High-Strength Bolts for Bridges

Report No. FHWA-SA-91-031

Addendum

(date of Addendum: April 14, 1994)

Fig. 19

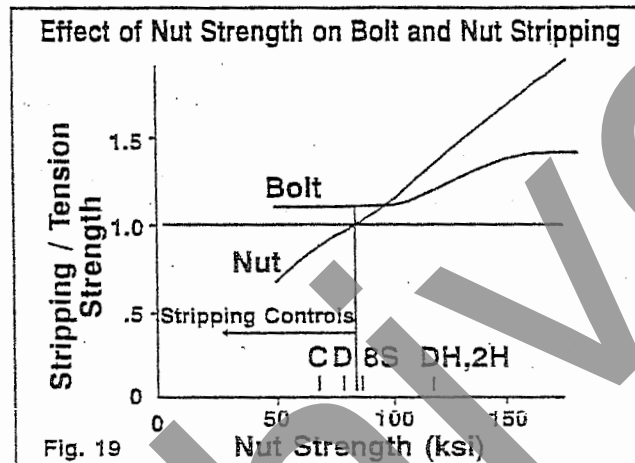
Alexander's model:
